Explore Garments Ltd.

17 December 2023

2. Observations

Observation-3: Non-structural elements found unbraced/not anchored (Main Production Building).

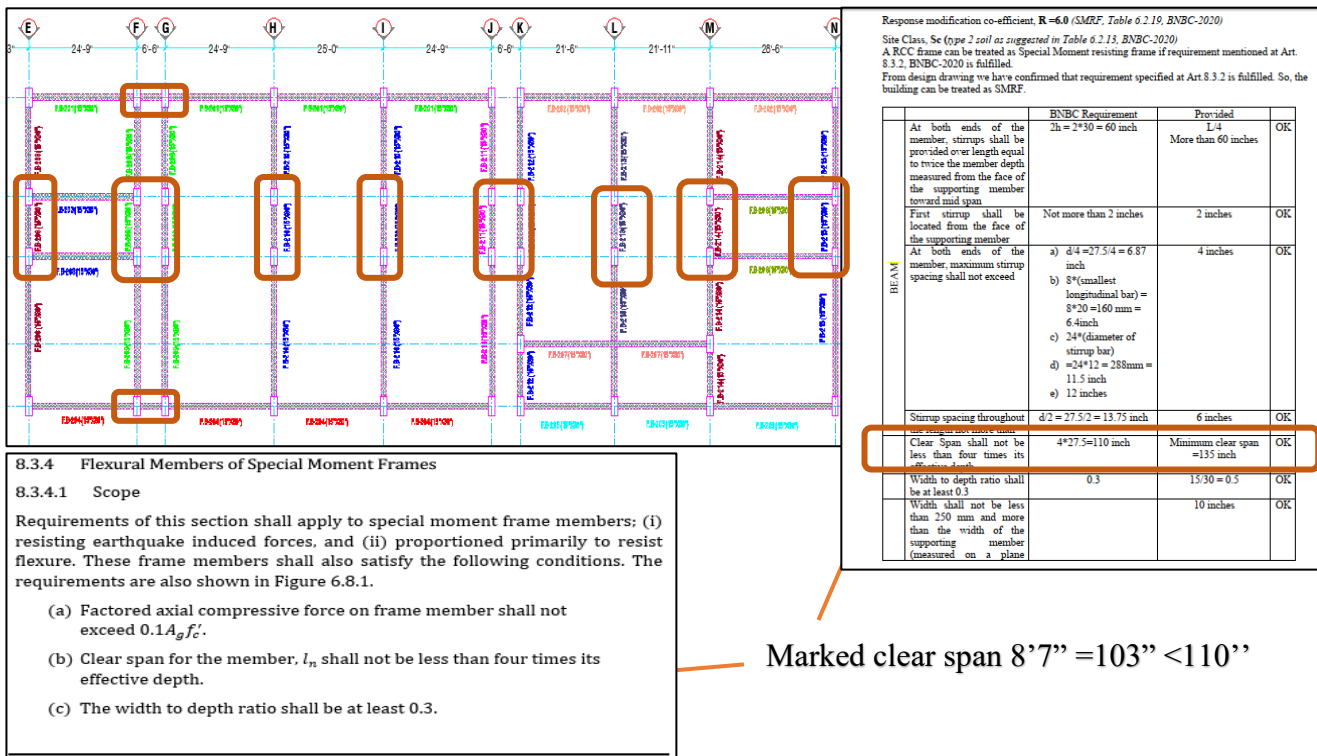
Description: Non-structural elements suspended from, attached to, or resting top the structure shall be adequately anchored and braced to resist earthquake forces. Factory is required to brace/anchor all non-structural elements.

Observation-4: Design Report needs to be updated (Utility Building).

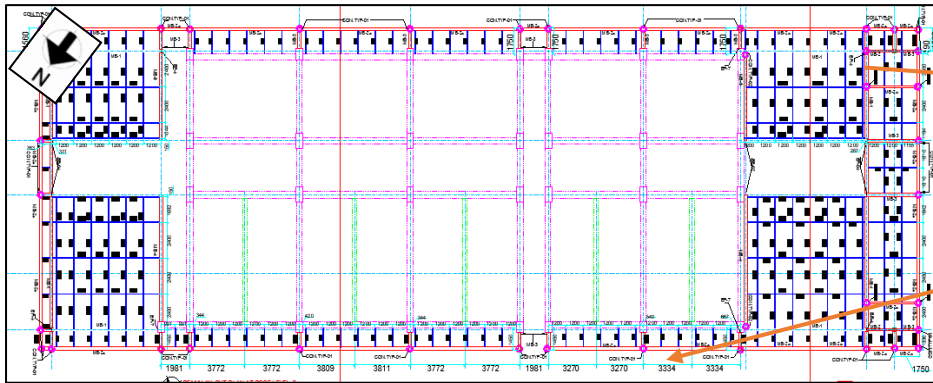
Description: Utility building has been designed in accordance with NBC 2020 considering Special Moment Resisting Frame (SMRF). Flexural members of the SMRF system have to comply with Sec. 8.3.4.1(b) of NBC 2020. However, several beams in the structural system observed not complying with this requirement. The building engineer is required to revise the design and design report with appropriate framing system complying with Table 6.2.19 and Sec 8.3 of NBC 2020.

Observation-5: Mismatch in as-built drawings (Utility Building).

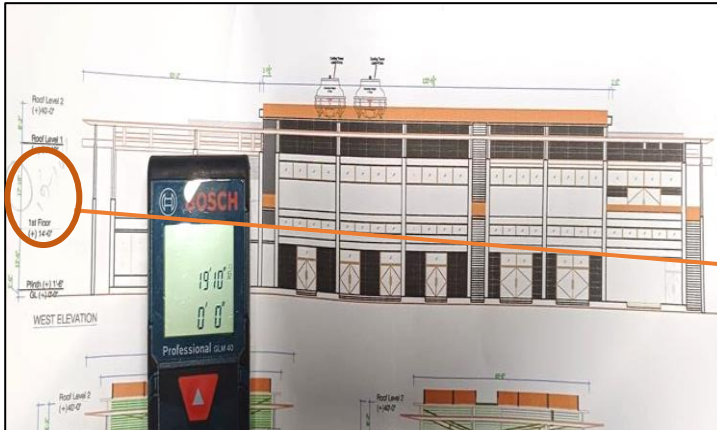
A steel pipe tray connected to the steel part which is absent in as-built drawings.

Floor to ceiling height was observed 6.04 m instead of 5.44 m.

Gardening at the roof – not shown in the drawing

Description: During the inspection, mismatches were found between the onsite condition and the as-built drawing. Water tank and roof top gardening was not shown in the drawing. Also, steel pipe tray is connected to the steel portion which has not shown in drawings. The building engineer is required to survey the full structure and produce accurate as-built drawings.
